Sydney Football Stadium Redevelopment (SSD 9835)

SECTION 4.55 (1A) MODIFICATION – MOD 3

Figure 1 – Proposed additions and reductions to mezzanine Level 1M (refer to Figure 2 for Location 1 and 2)

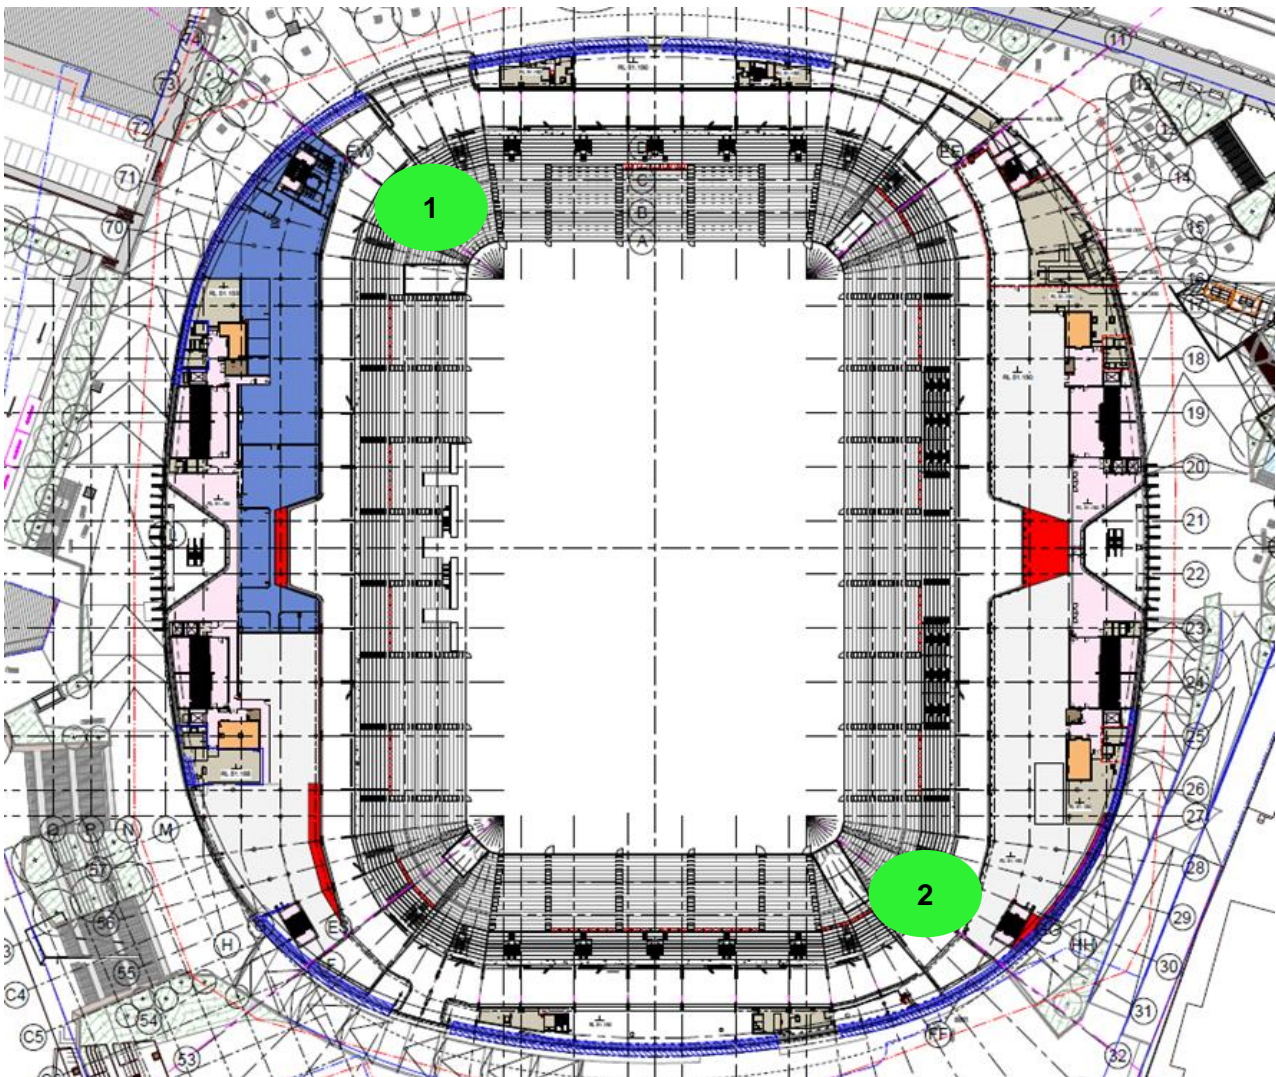
Following further design development by John Holland, opportunities to augment the approved extent and configuration of the mezzanine level have been identified as identified in Appendix A and reproduced in Figures 1 and 2 below. Areas shaded red identify additional floor slab and areas shaded green slab. The net delta equates to an 361.218m^2 compared to the approval.
